# UNITED STATES PATENT AND TRADEMARK OFFICE

APPLICATION NO.	FILING DATE	FIRST NAMED INVENTOR	ATTORNEY DOCKET NO.	CONFIRMATION NO.
10/786,456	02/25/2004	Christian Krueger	2000.109900	4909
23720	7590	06/15/2005	EXAMINER	
WILLIAMS, MORGAN & AMERSON, P.C. 10333 RICHMOND, SUITE 1100 HOUSTON, TX 77042			JOHNSTON, PHILLIP A	
			ART UNIT	PAPER NUMBER
			2881

<b>Office Action Summary</b>	<b>Application No.</b>	<b>Applicant(s)</b>	
	10/786,456	KRUEGER, CHRISTIAN	
	<b>Examiner</b>	<b>Art Unit</b>	
	Phillip A. Johnston	2881

FIG. 1

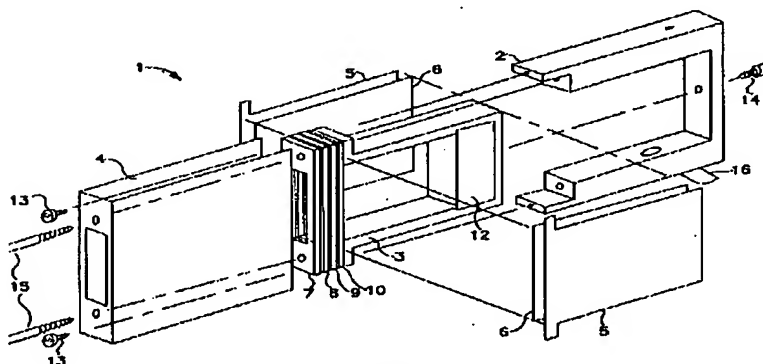
Turner (002) discloses a Faraday cup design including a bottom 12, walls 6, aperture 4, and plural aperture plates 7-9; where the conductive collector surfaces; e.g., inner cup frame 3, substrate 12 and aperture plates 7-9, are insulated from each other and have different orientations to the ion beam, as recited in claims 1-12, and 26-34. See Column 4, line 23-52; Figures 1 and 2 below.

FIG. 2

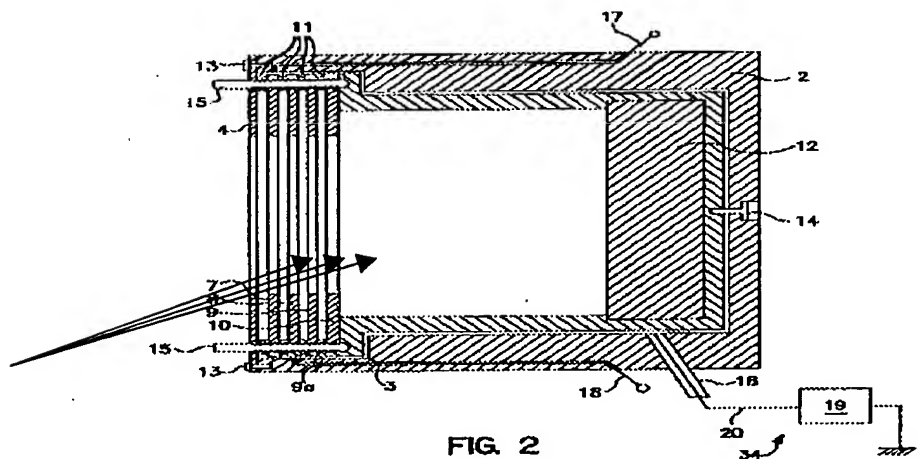
In addition, it is implied in Figure 2 above that, aperture plates 7-10, are each conductive regions positioned at different angles (see arrows) relative to a single point on the longitudinal axis, as recited in claims 10-12.

FIG. 1

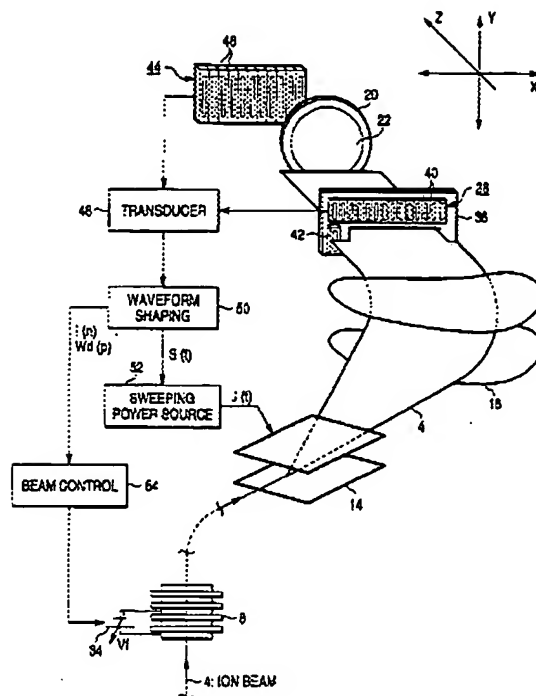
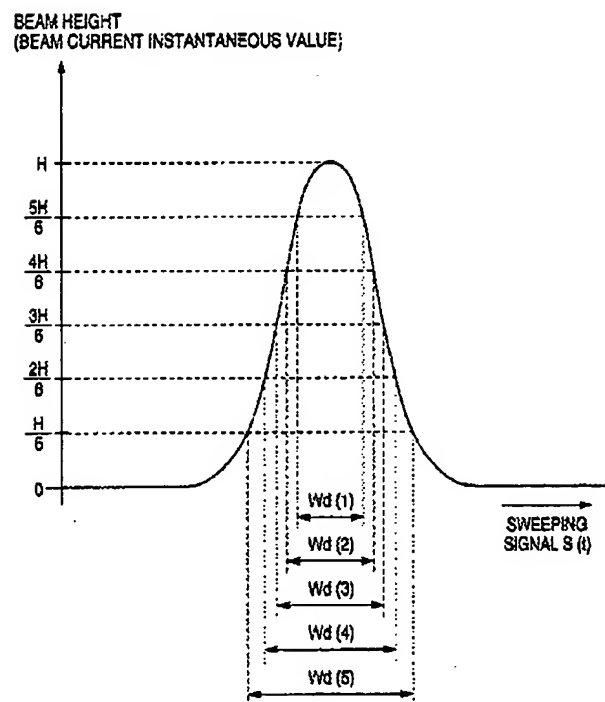
Iwasawa (027) discloses an ion implantation apparatus; wherein the beam width is measured using a plurality of faraday cups 40 and 46 positioned to collect ion current across the beam and generate a beam width waveform shown in Figure 3 below. Thereafter beam controller 54 is used to control divergence of the beam, as recited in claims 13-25. See Column 3, line 16-39; Column 5, line 41-50; Column 6, line 51-67; Figures 1 and 3 below.
